SMYRNA MUNICIPAL PLANNING COMMISSION

MEETING MINUTES JANUARY 9, 2025

1. 7 Brew

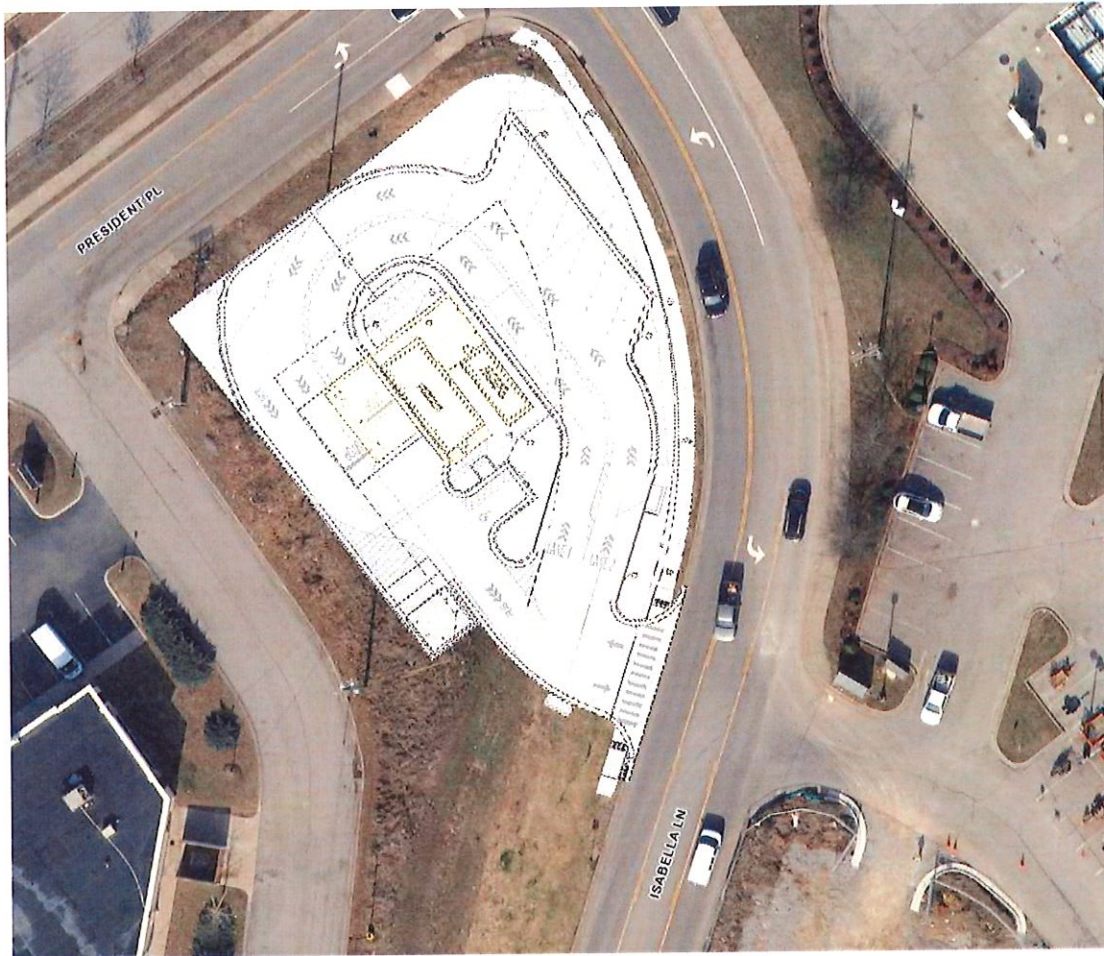
Landscape plan shows boxwood shrubs planted throughout the site with sugar maple and willow oaks. As shown, the landscape plan does not meet Design Review Manual requirements for streetscaping.

Architectural elevations show the building to be finished with a mixture of brick, glass/glazing, fiber cement siding and metal. All sides of the building must meet the Design Review Manual requirement of a minimum 75% primary materials due to the visibility from all road frontages. The elevations will need to be further detailed to determine if requirements are met.

1. Approval of this site plan would be subject to the approval of the rezoning request to C-2 by the Town Council.
2. Submit the required water load sheet for water meter sizing.
3. There is a left turn lane conflict with Home Depot. This conflict must be addressed.
4. Revise the landscape plan to meet the Design Review Manual.
5. A sidewalk is required along the entire lot frontage along Isabella Lane.
6. Provide building material percentages for each wall elevation as well as the entire building.
7. Revise architectural elevations to meet Design Review. All four sides of the building are required to be 75% primary materials. Concrete siding is not a primary material. Please detail what is meant by "siding" for the materials used and show the percentage for each material.
8. Sewer service shall be 6".
9. Submit hard copies of the elevations.

Staff Recommendation: Staff recommends deferral or denial due to the site work required to be modified with the comments listed above.

3. Janet Ibrahim
Rocky Fork Road
Owner / Developer: Janet Ibrahim

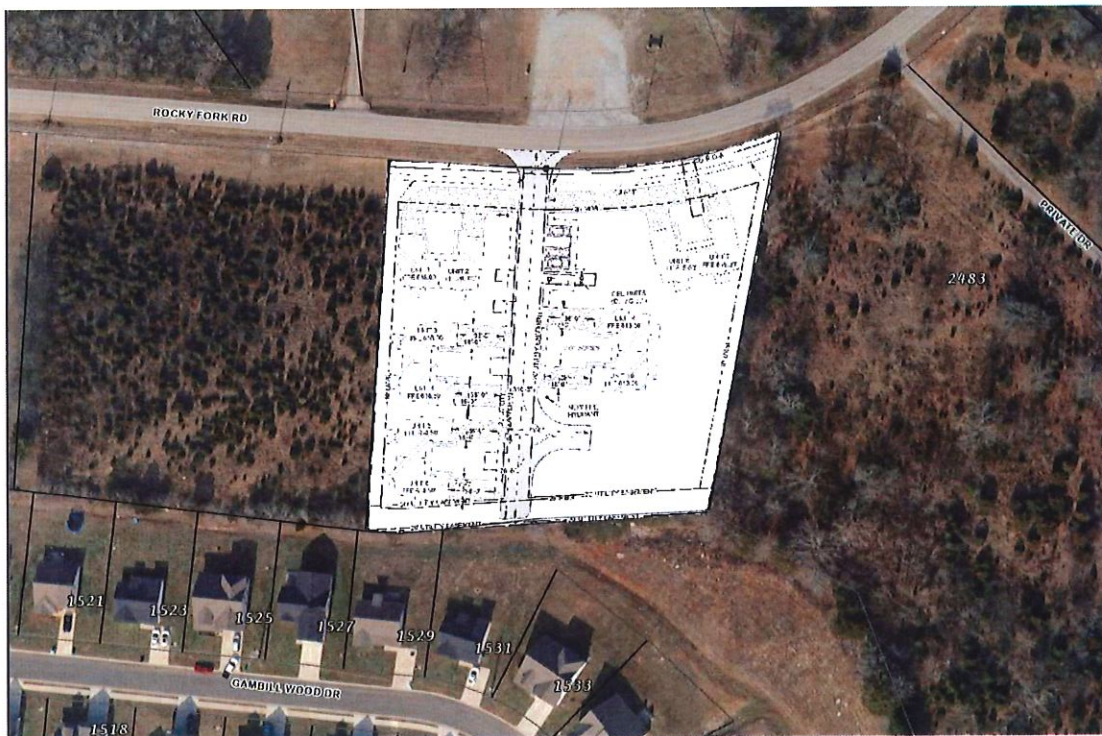
1. Submit the required water load sheet for water meter sizing.
2. Submit and record the final plat prior to receiving building permits. Show right-of-way dedication and utility easements on the plat.

3. How is the drainage going to the detention pond? Please show on the plans.
4. Provide documentation where the developer has permission from the adjacent property owner to extend the sewer through the easement.

5. Submit architectural elevations to match what is shown on the approved PRD.
6. Landscape and storm structures cannot overlap. Out fall running through the buffer.

7. Provide parking details.
8. Show all existing utilities around offsite sewer tie-in.
9. The maximum run of a sewer main from manhole to manhole is 350 feet.

10. Submit profile pages for proposed water and sewer mains.
11. Submit a full set of construction plans.
12. Submit a plan showing proposed lighting and screening consistent with the requirements of the Enon Springs Overlay.

13. Show the existing tree canopy area including which portion of it will be preserved.
14. Provide a color palette for the proposed buildings.
15. Show the existing water, sewer and gas mains on Gambillwood Drive.
16. Why are existing trees being shown on top of sewer lines?
17. No trees are allowed within sewer easements.
18. Show all proposed easements and offsite sewer easements.
19. Submit road name and E911 approval of that road name.
20. Show crosswalk where truncated domes are located.

Staff Recommendation: Staff recommends denial or deferral due to the list of outstanding comments remaining.

4. Murphy USA
584 Enon Springs Road, East
Owner / Developer: Murphy Oil USA, Inc.

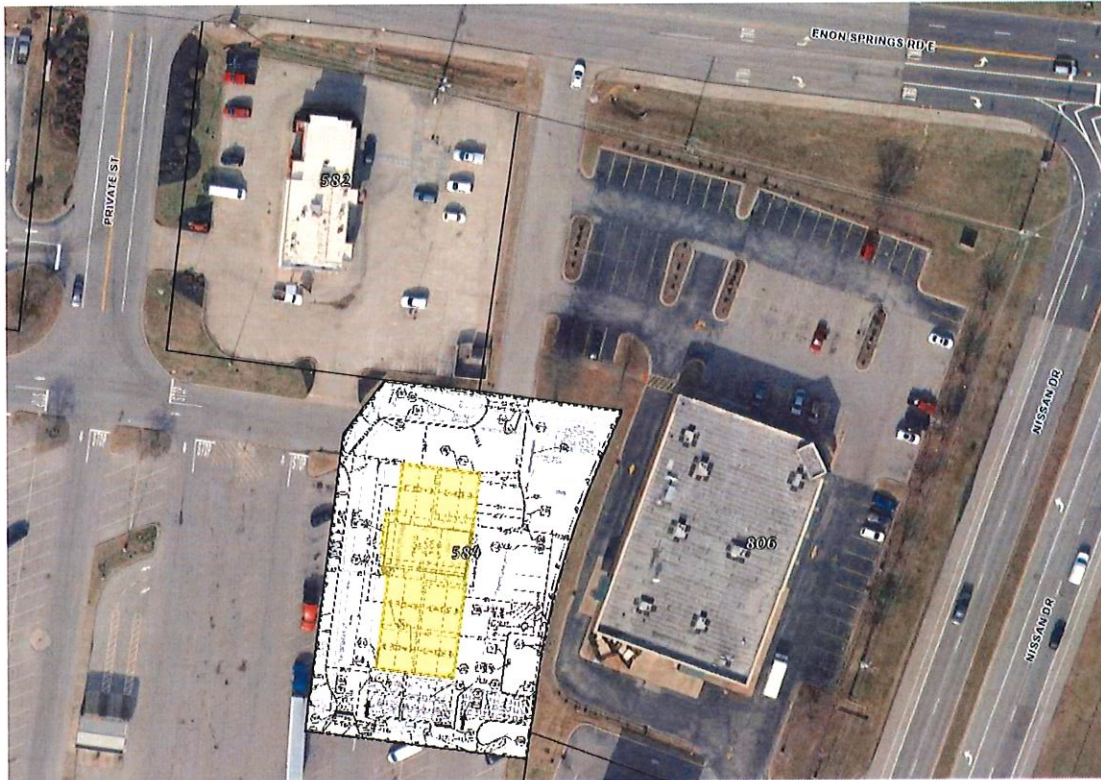
Architectural elevations submitted show a mixture of brick, glass/glazing and architectural composite metal panels (ACM). Percentages have not been shown to verify whether the elevations meet Design Review requirements.

1. Provide architectural elevations with percentages on each wall face and building as a whole.
2. The relocation of the fuel tanks requires a State permit.
3. Provide a 6 inch sewer service.
4. Water service needs a backflow preventer with a hot box.
5. Provide sewer cleanouts at a maximum of 75'.
6. Use water and sewer details from the Town of Smyrna water and sewer specifications.

Staff Recommendation: Staff recommends approval with above listed comments.

5. Stewart Creek Retail
Intersection of Poplarwood Drive & Almadale Road
Owner / Developer: Mayan 2022, Inc.

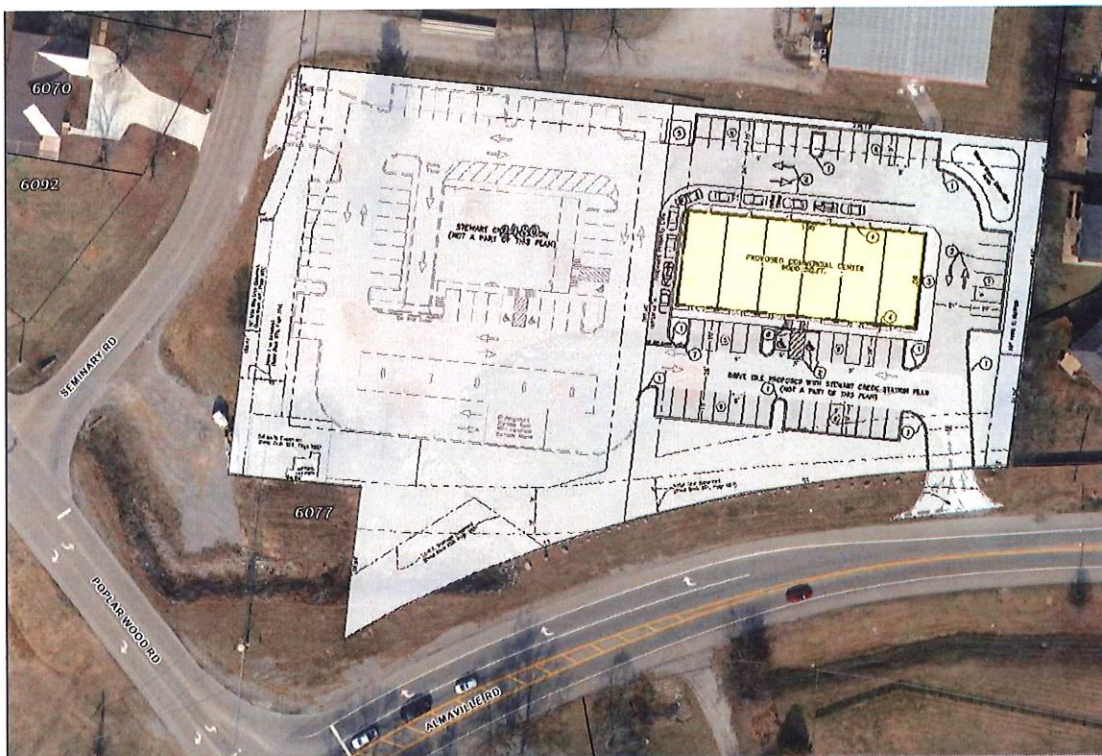
1. Submit required water load sheet for water meter sizing.
2. Submit final plat to be recorded prior to receiving building permits.
3. Add a raised curb at the right-in and right-out only access point off of Almaville Road.
4. Owner must submit a Water Service Availability request to CUDengineering@ cudrc.com to receive a Will Serve letter from CUD.
5. CUD has an existing 12" water main along Almaville Road that should be able to meet the 1,500 GPM flow requirement to this site.
6. Once available, for specific comments, submit full set of plans directly to CUDengineering@ cudrc.com for future review and comment.

Staff Recommendation: Staff recommends approval with the above listed comments.
